United States Patent and Trademark Office

APPLICATION NO.	FILING DATE	FIRST NAMED INVENTOR	ATTORNEY DOCKET NO.	CONFIRMATION NO.
10/749,396	01/02/2004	Takeshi Yamamoto	247209US2	2864
22850	7590 01/18/2006		EXAMINER	
OBLON, SPIVAK, MCCLELLAND, MAIER & NEUSTADT, P.C. 1940 DUKE STREET			CHEN, WEN YING PATTY	
	DRIA, VA 22314		ART UNIT	PAPER NUMBER
			2871	
			DATE MAILED: 01/18/200	6

Application No.	Applicant(s)	_			
	10/749,396	YAMAMOTO, TAKESHI	m			
Office Action Summary	Examiner	Art Unit	<u> </u>			
	Wen-Ying P. Chen	2871				
The MAILING DATE of this communication ap Period for Reply	opears on the cover sheet with the	correspondence address				
A SHORTENED STATUTORY PERIOD FOR REPLY WHICHEVER IS LONGER, FROM THE MAILING IDENTIFY of time may be available under the provisions of 37 CFR 1 after SIX (6) MONTHS from the mailing date of this communication. If NO period for reply is specified above, the maximum statutory period Failure to reply within the set or extended period for reply will, by statu Any reply received by the Office later than three months after the mailing earned patent term adjustment. See 37 CFR 1.704(b).	DATE OF THIS COMMUNICATIO .136(a). In no event, however, may a

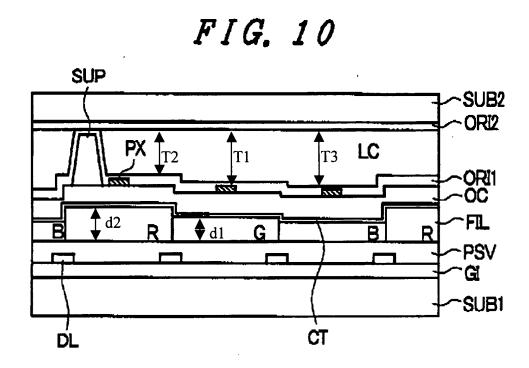
With respect to claim 1 (Amended): Ochiai et al. disclose in Figure 10 a liquid crystal display apparatus comprising:

a plurality of pixels which are disposed in a matrix (Column 8, lines 12-15), the pixels including a first pixel with a first gap (element T1 as indicated in the figure below) for interposition of the liquid crystal layer (element LC) between the first substrate (element SUB1) and the second substrate (element SUB2), and a second pixel with a second gap (element T2 as indicated in the figure below) that is smaller than the first gap, the first pixel including a first color filter layer that has a first film thickness and mainly passes first color light, and the second pixel including a second color filter layer that has a second film thickness, which is greater than the first film thickness, and mainly passes second color light; and a columnar spacer (element SUP) for creating the second gap, the columnar spacer being disposed not at the first pixel but at the second color filter layer at the second pixel.

Ochiai et al. fail to disclose that the first color filter passes the first color light having a wavelength that is greater than a wavelength of the second color light.

However, Haim et al. disclose a liquid crystal display comprising of a first color filter (element 16B) having a first gap passing a first color light and a second color filter (element 16A) having a second gap smaller than the first gap passing a second color light, wherein the first color light has a wavelength greater than the second color light.

Therefore, it would have been obvious to one of ordinary skill in the art at the time the invention was made to construct a liquid crystal display apparatus as taught by Ochiai et al. wherein the color filter thickness with respect to the wavelength is structured as taught by Haim et al., since Haim et al. teach that such structure of the color filter increases the uniformity of optical radiation as function of angle thus provide a wide viewing angle of the display device (Column 2, lines 10-13 and 28-32).

As to claim 8: Ochiai et al. further disclose in Figure 10 that the plurality of pixels further include a third pixel with a third gap (element T3) that is greater than the first gap (element T1).
